Addendum #3

Bid Opportunity: 25-7693-RFT - Elmira District Secondary School Weight Room Renovation Closing Date: Thursday, March 20, 2025 2:00 PM

WRDSB-Elmira District Secondary School Weight Room Renovation
WRDSB Project No.: 25-7693-RFT
WF Project No.:2022-0277-15

March 13, 2025
ADDENDUM #3
Page 1 of 2

SCALE :	1 : 20	SHEET NO : A801
DATE :	2025.02.26	
PROJECT NO :	2022-0277-15	
DRAWN BY :	CS	
CHECKED BY :	MM

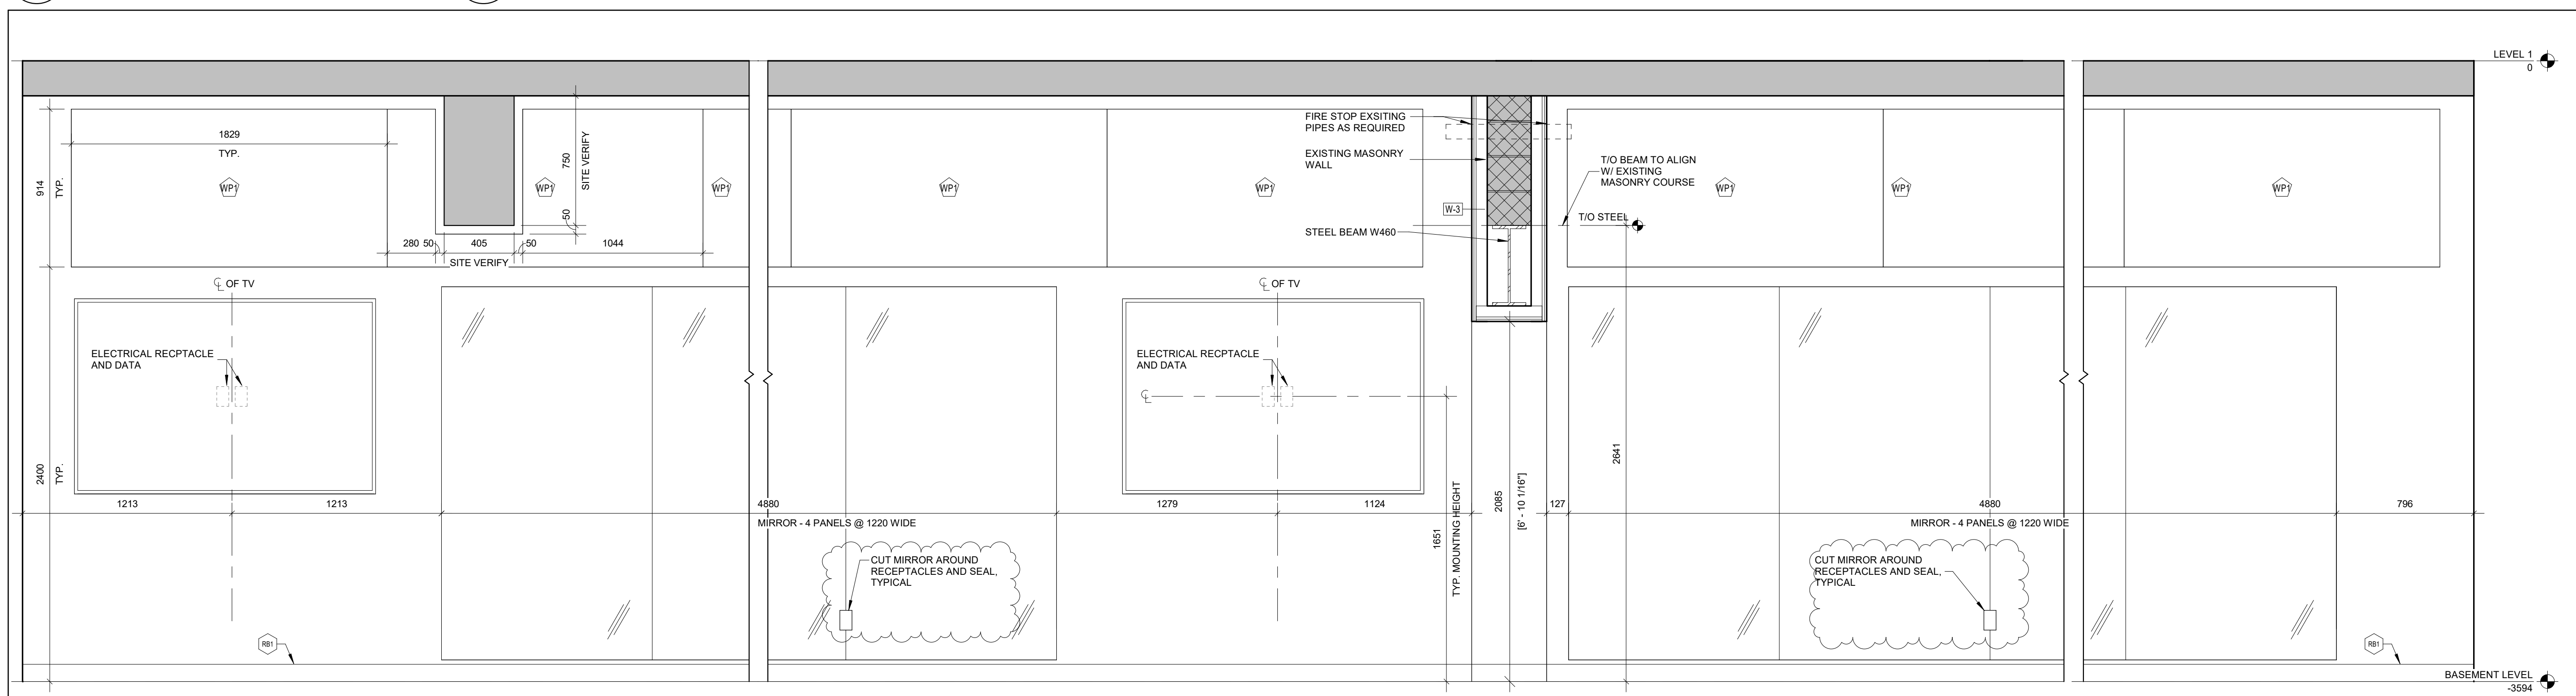
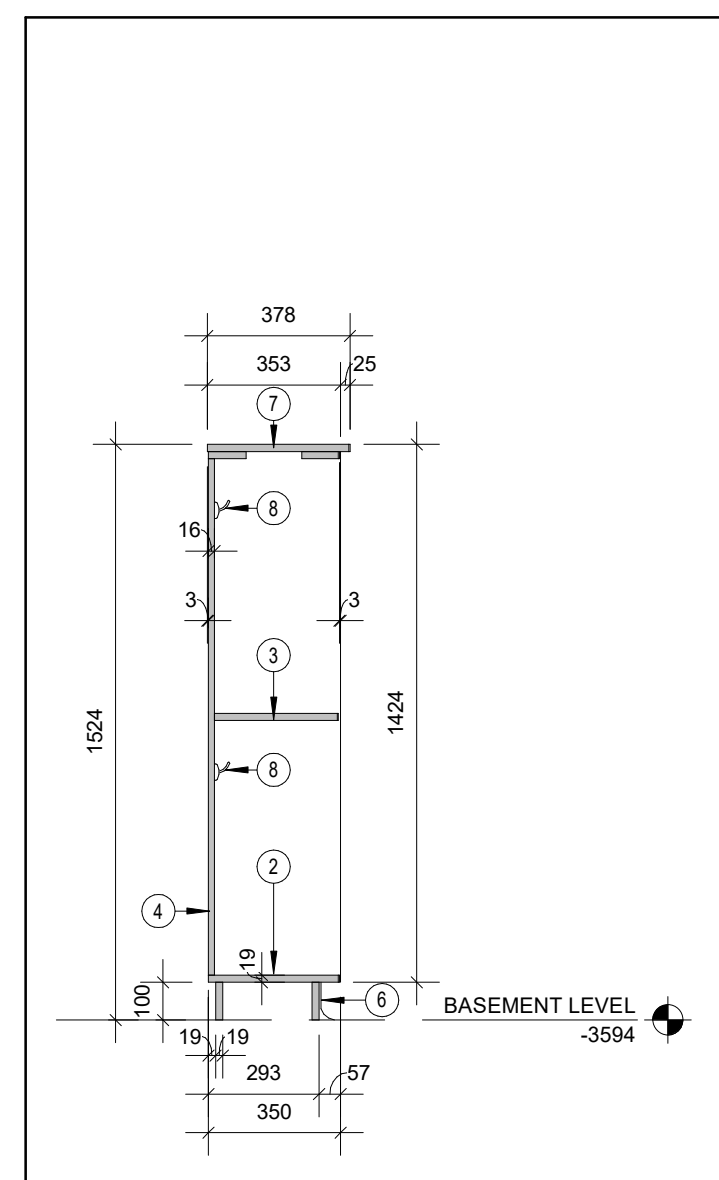
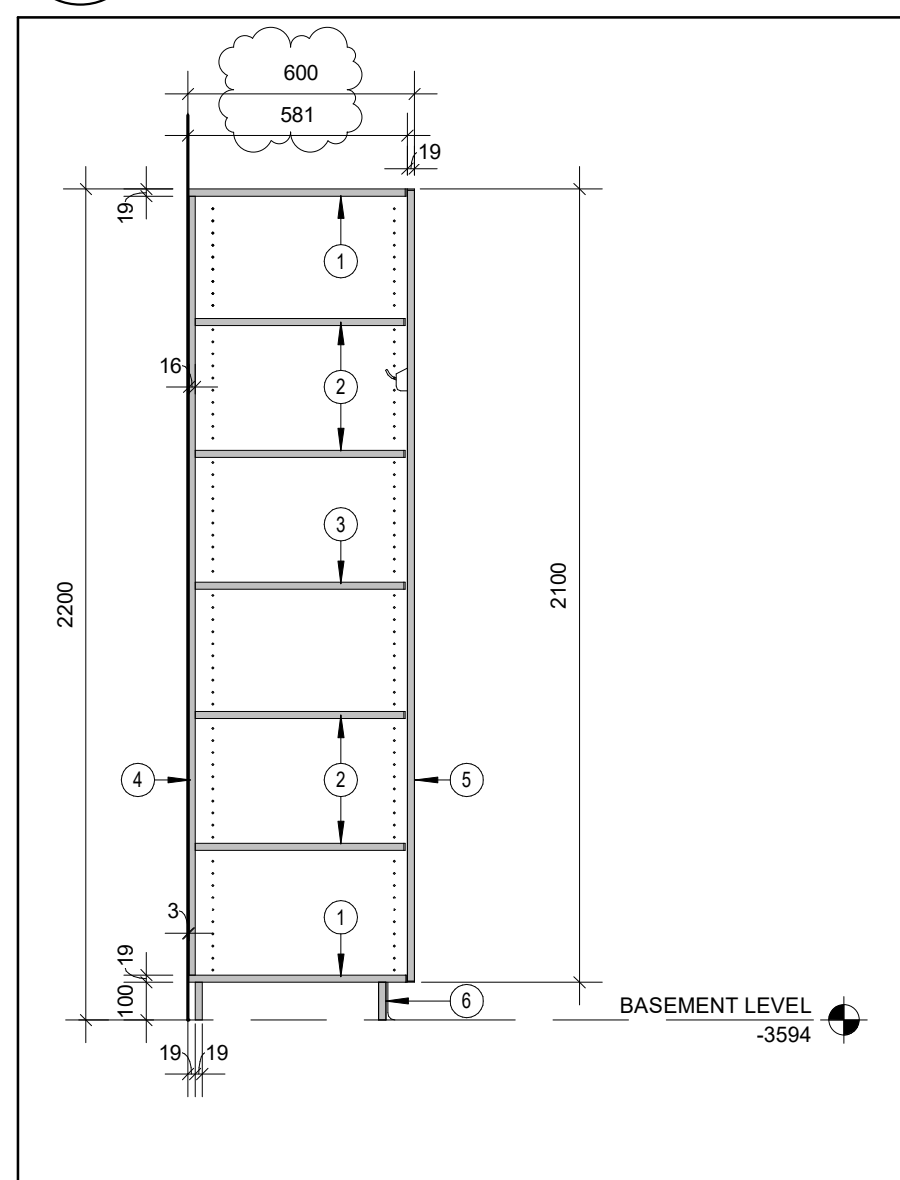
A801

1. In 3/A801 revised depth of teachers closet to 600mm.
2. Add note to 5/A801 to read "Cut mirror around receptacles and seal, typical".

SCALE:	As Indicated	SHEET NO.:
DATE:	2025.02.26	A901
PROJECT NO.:	2022-0277-15	
DRAWN BY:	CS	
CHECKED BY:	MM

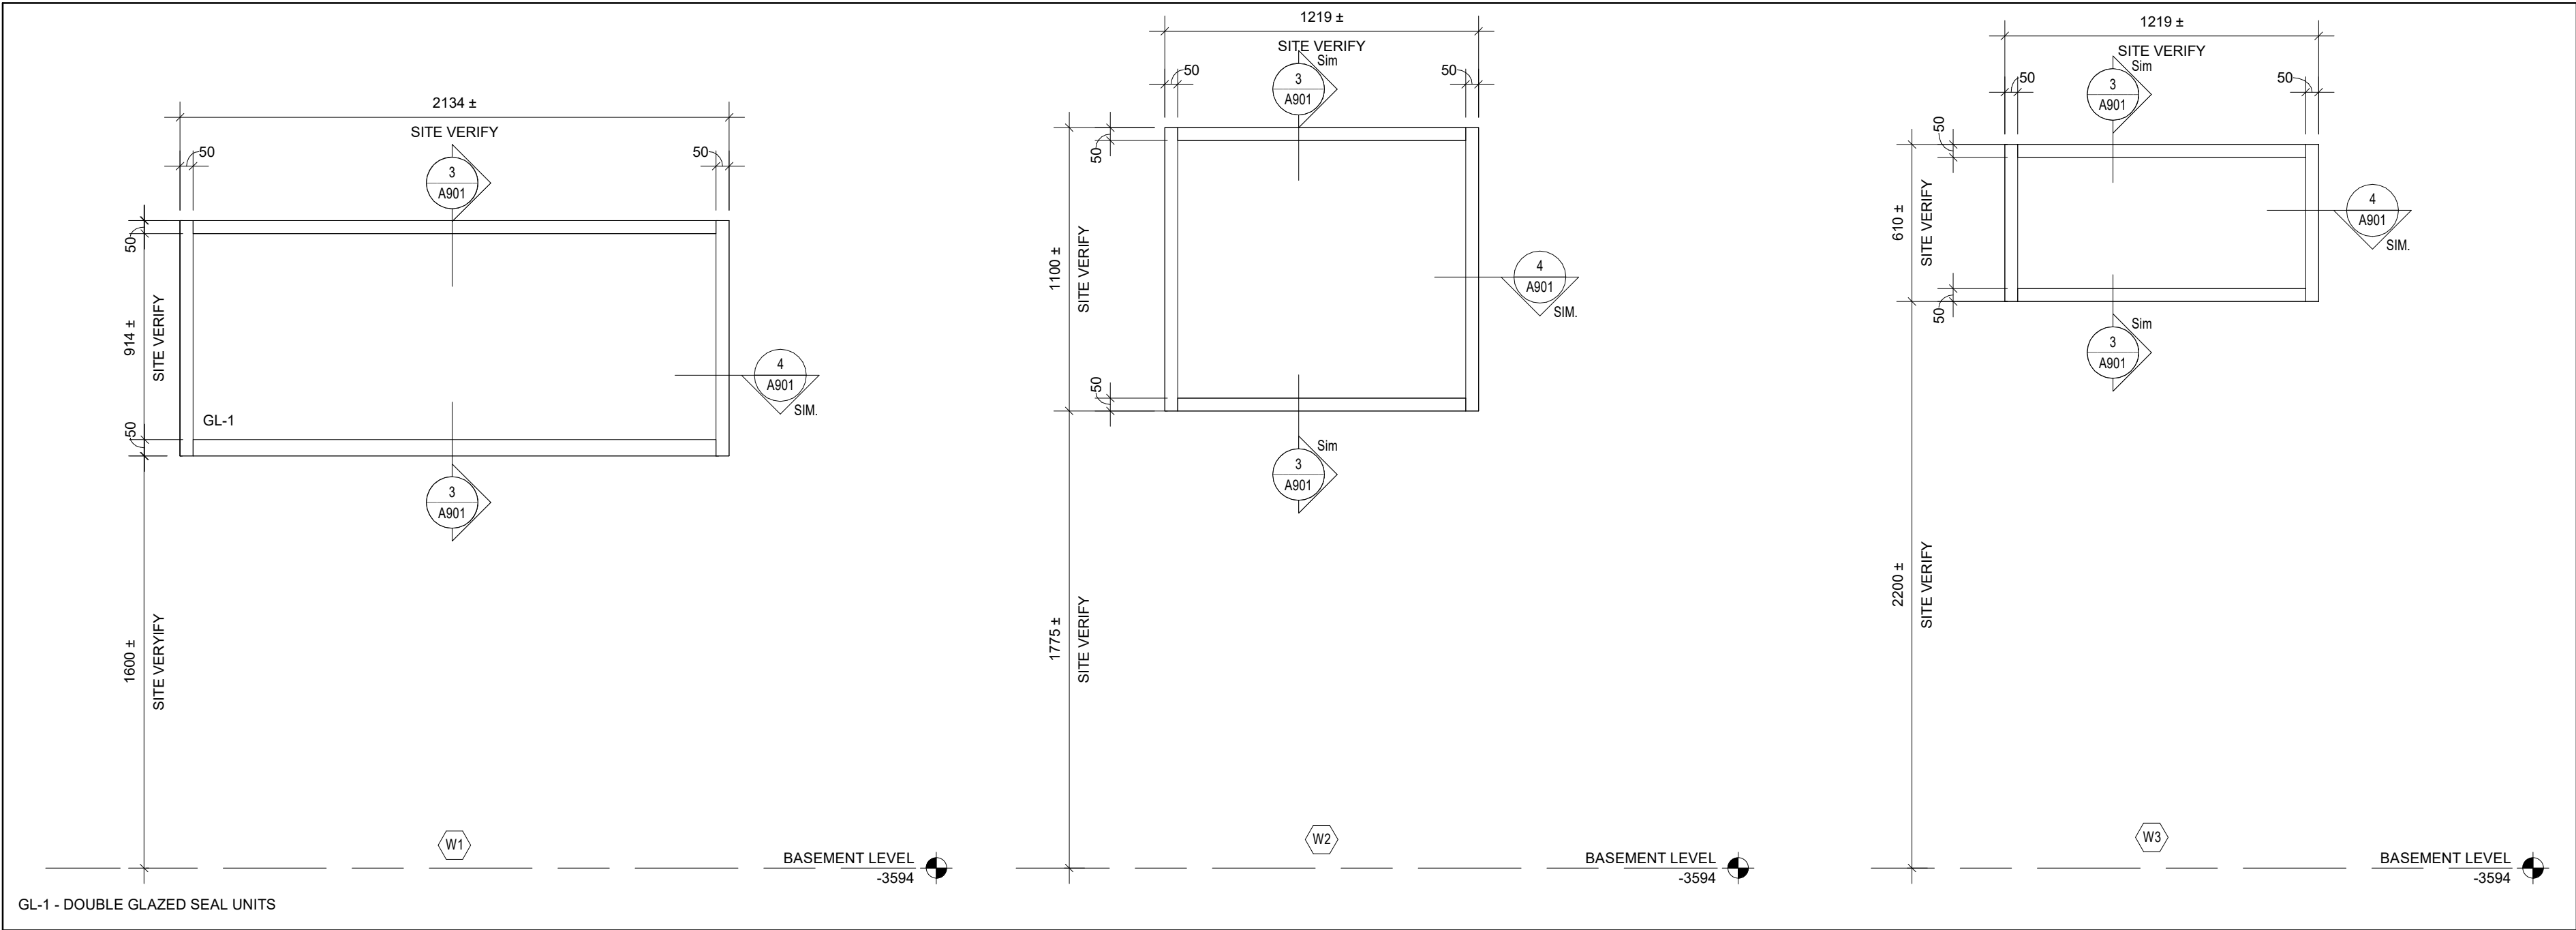
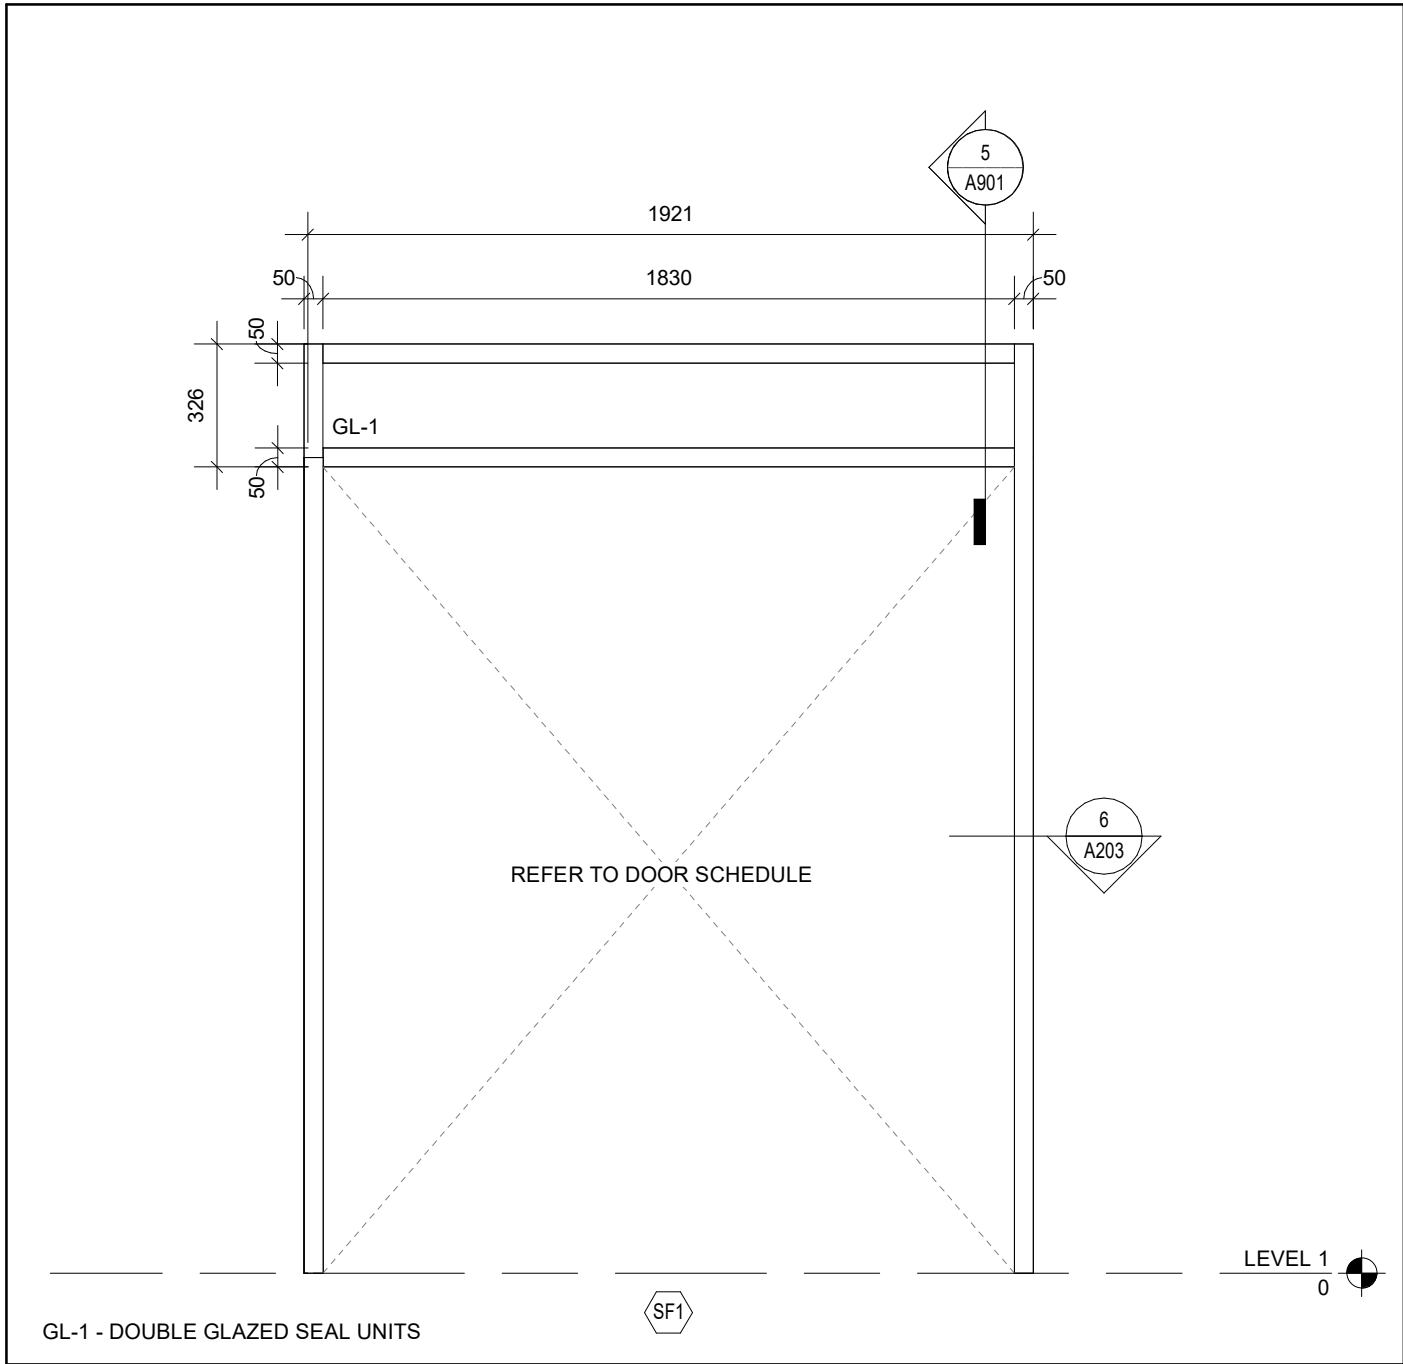
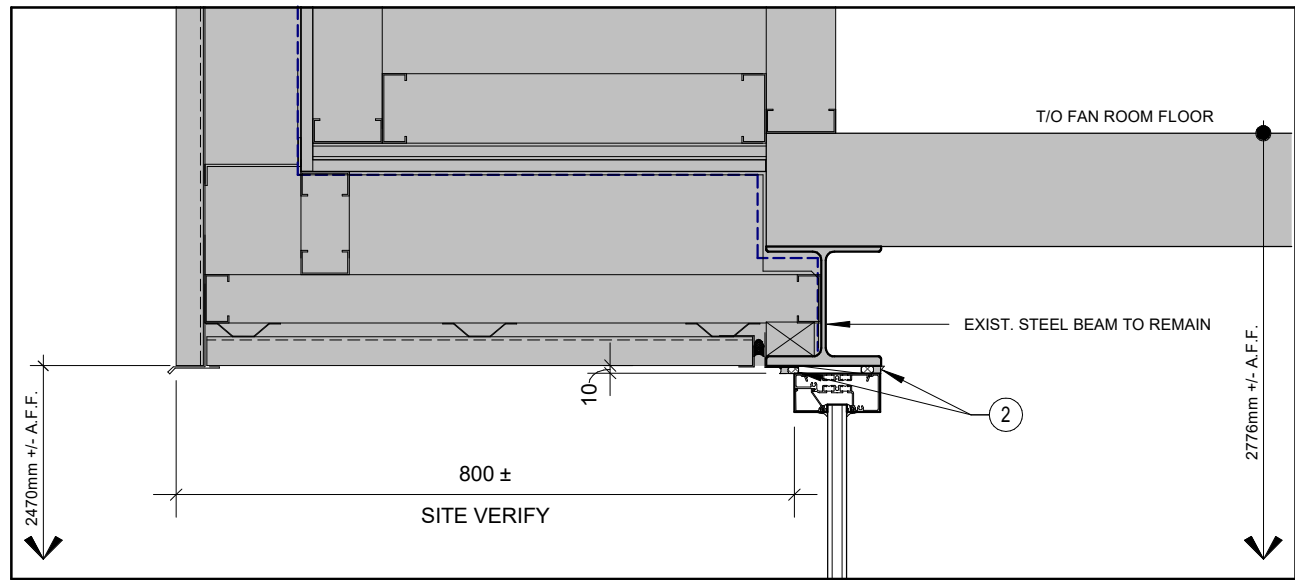
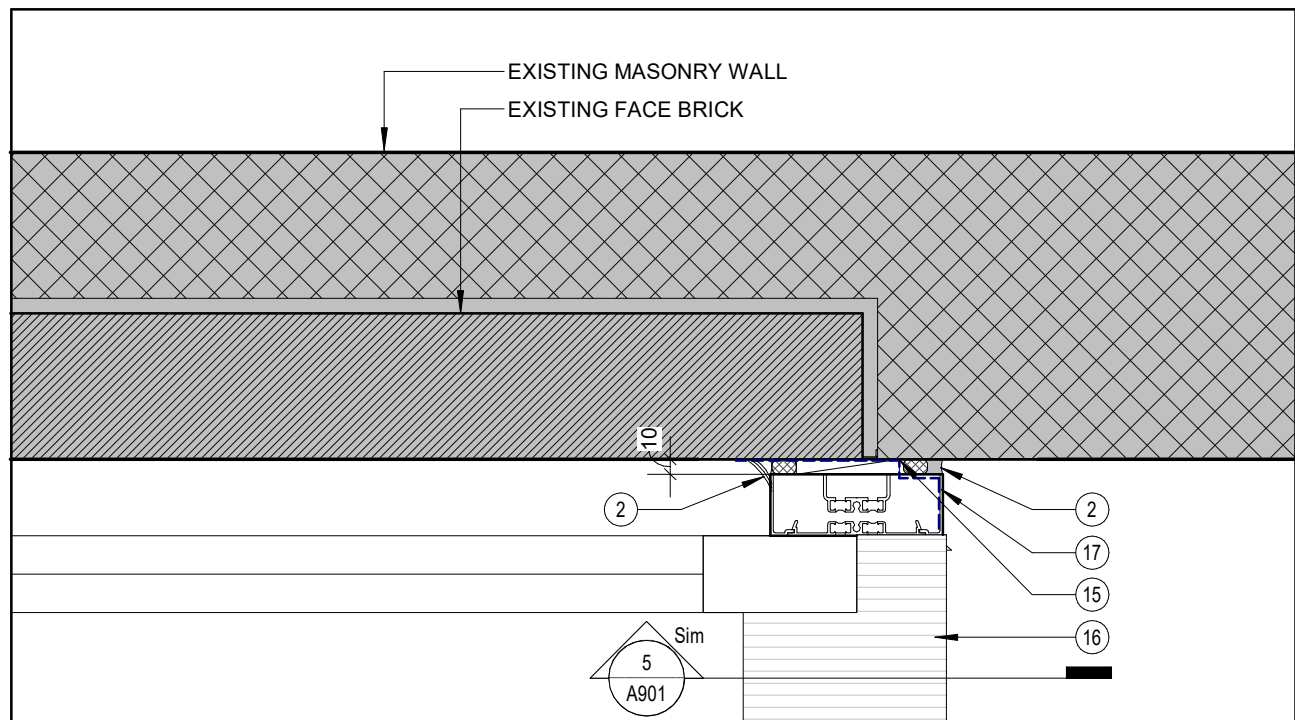
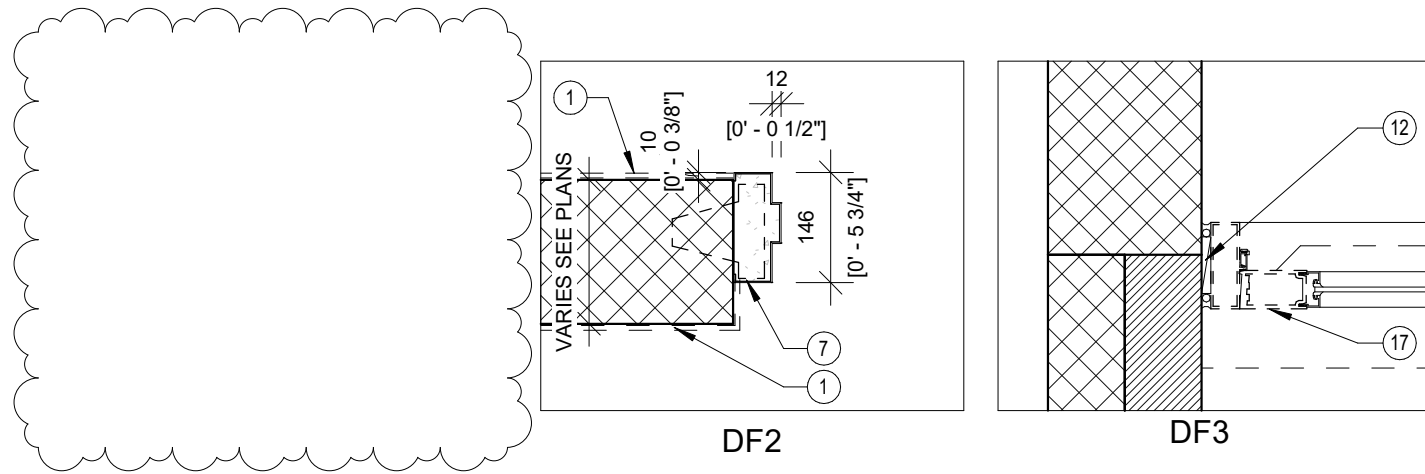
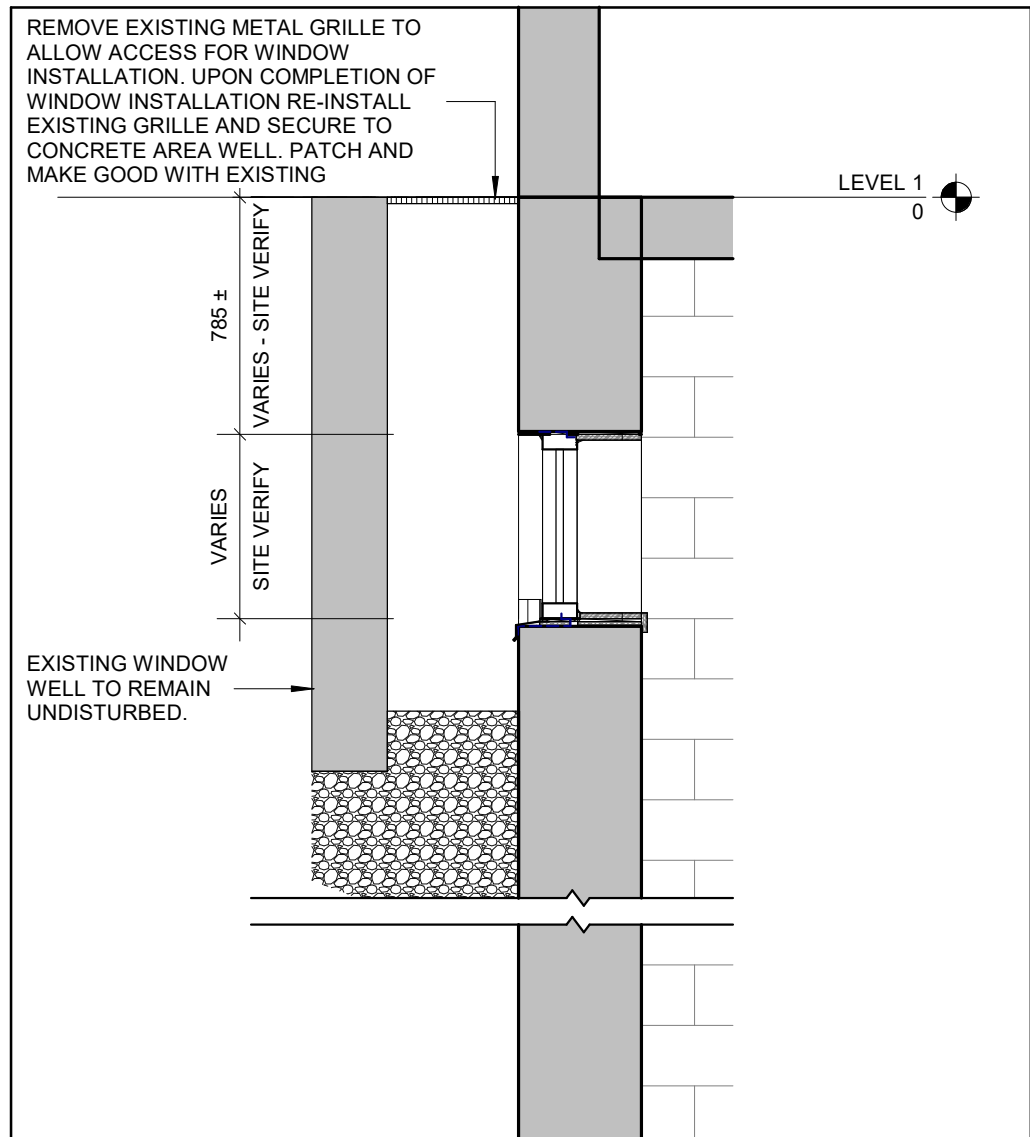
A901

1. Remove "DF1"
2. Revised door 0002a frame profile to DF2 in door schedule.
3. Add detail "M108e"
